World Forum for Harmonization of Vehicle Regulations

Working Party on Noise and Tyres

Tyres: UN Regulation No. 109 (Retreaded tyres for commercial vehicles and their trailers)

Proposal for amendments to UN Regulation No. 109

Annex 3,

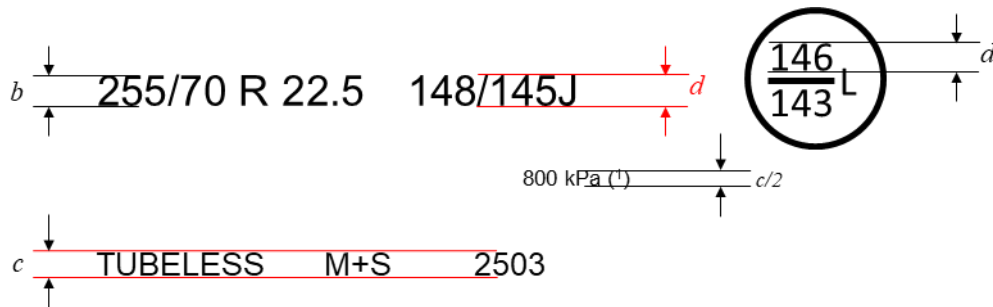
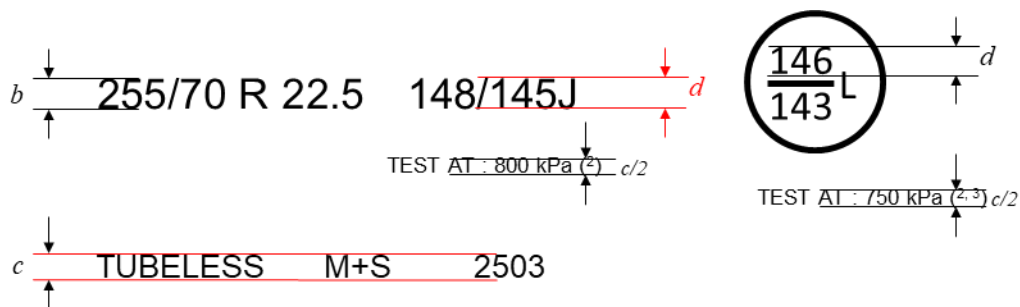
Figure, replace and amend to read:

- (1) PSI marking instead of kPa is allowed for tyres first type approved before 1 January 2018. The kPa marking may be preceded by "TEST AT : " or, alternatively, by "TEST INFL : " or the symbol "@".

- (2) "TEST AT : " may be replaced by "TEST INFL : " or the symbol "@ " or be omitted.
 (3) The indication of a second inflation pressure for the additional service description is optional. If there is no indication, the same test inflation applies to both load/speed combinations.

- (4) For "ML" and "MPT" being part of the tyre size designation marking the minimum dimension *b* applies."

Requiring to be inflated to ~~620~~**800** kPa for **both** load/speed endurance tests **in Example 1 and 800 kPa for the load/speed endurance test according to the main load/speed combination and 750 kPa for the test according to the additional load/speed combination in Example 2** for which the PSI symbol is ~~90~~."

- “(e) **If there are two indications for the test inflation pressure, they must be placed in such a way that it is clear which pressure indication belongs to which load/speed combination.**”
